29 March 2019

RE: GOLDEN VALLEY II WIND ENERGY FACILITY – AMENDMENT– AVIFAUNAL STATEMENT

Figure 2. Layout of pre-construction bird monitoring relative to the new project layout.

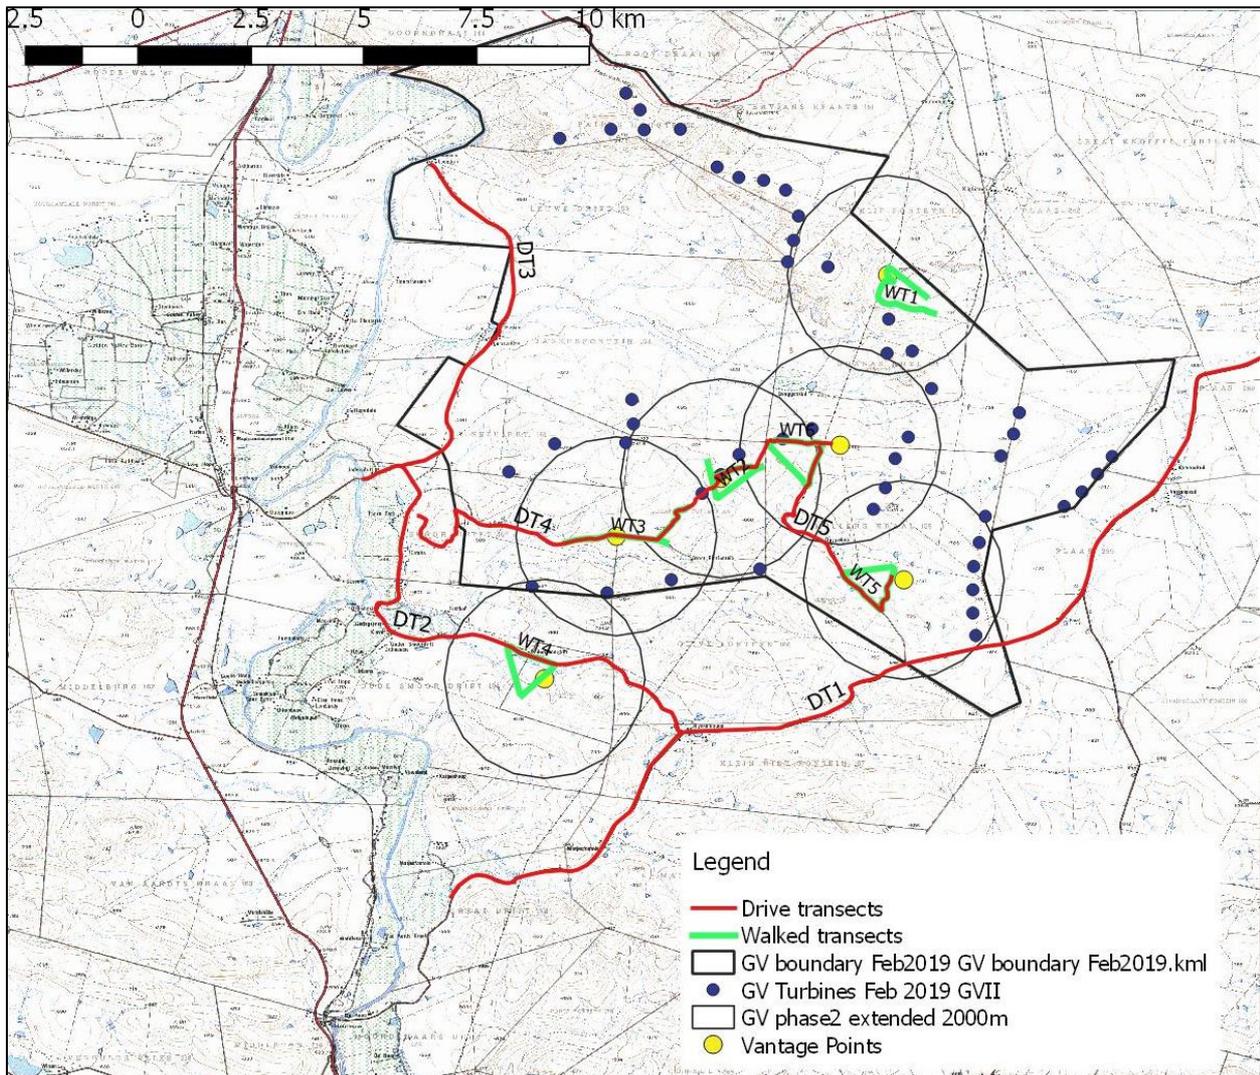
Figure 2 shows the new layout proposed under the current (2019) amendment. There are turbines further west in the north-western corner, and further east in the north-eastern corner than previously. These areas were not covered by vantage point monitoring in the previous pre-construction bird monitoring. However based on the general characteristics of the avifauna on site, and in particular the low level of flight activity we recorded on site for priority bird species, we are comfortable that the findings we made previously would apply also to these new turbine positions. We have conducted pre and post construction monitoring

at the adjacent Cookhouse West, Nojoli, Amakhala Emoyeni and Golden Valley I sites and have extensive understanding of the avifaunal issues in this area.
